APPLICATION NO: 15/01441/OUT		OFFICER: Mr Ed Baker
DATE REGISTERED: 15th August 2015		DATE OF EXPIRY : 10th October 2015
WARD: Battledown		PARISH: CHARLK
APPLICANT:	Mr R.J. Ashton	
LOCATION:	Land Off Harp Hill Charlton Kings	
PROPOSAL:	Outline application for the erection of dwelling (revised submission following refusal of 14/01612/OUT)

REPRESENTATIONS

**ACCESS APPRAISAL OF THE
EXISTING DRIVEWAY SERVING
'ROSE ORCHARD' AND 'KINGS WELCOME'
HARP HILL
CHARLTON KINGS**

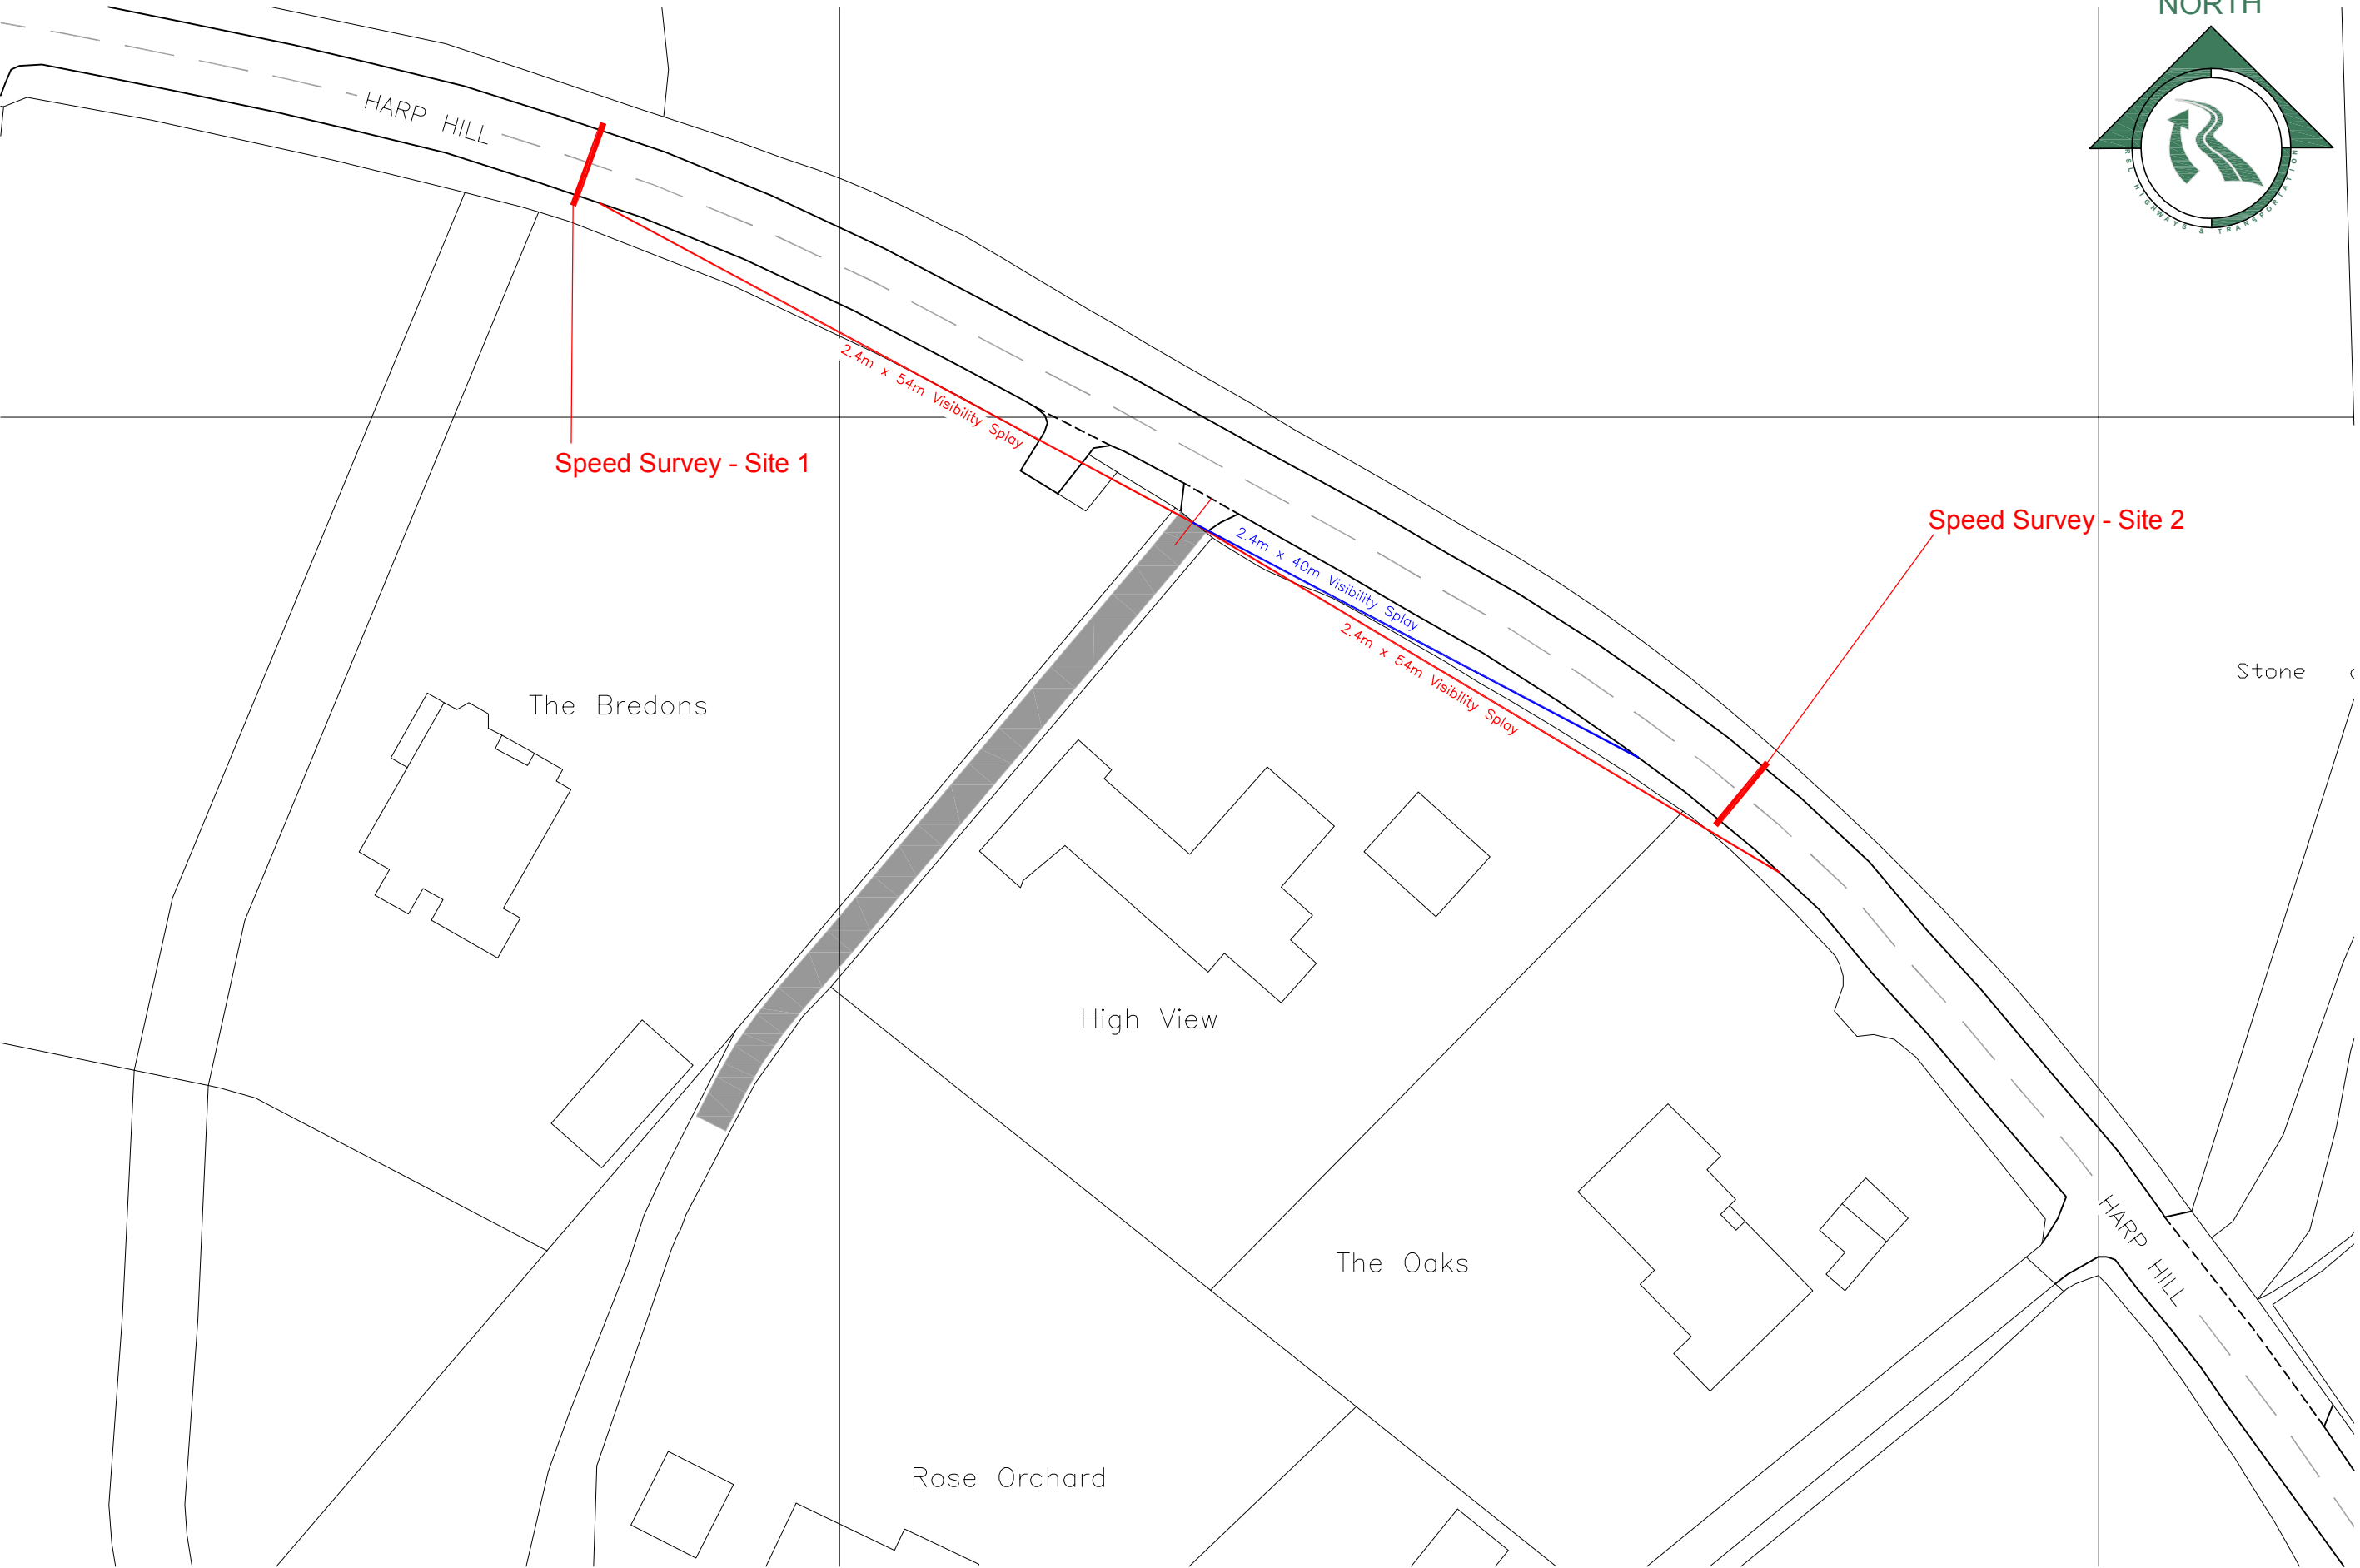
- 3.12 Using Manual for Streets 2(MfS2), the splay required is 40m. Details of the calculation is contained in Appendix 5.
- 3.13 A drawing contained in the application documents titled “Access Arrangement with Visibility Splays” (see Appendix 8) illustrates that a splay of 54m is achievable. The drawing shows the large trees, however, the hedgerow is not shown. The latter severely impacts on visibility. Below is an extract of the drawing with the achievable splay and correct line of vegetation shown:-

3.15 The drawing contained in Appendix 1 illustrates the splay for 54m and 40m. In addition the property boundaries can also be seen. If the vegetation was not a restriction then it is likely 3rd party land ownership issues would be. A detailed Land Registry Search is required to confirm boundaries.
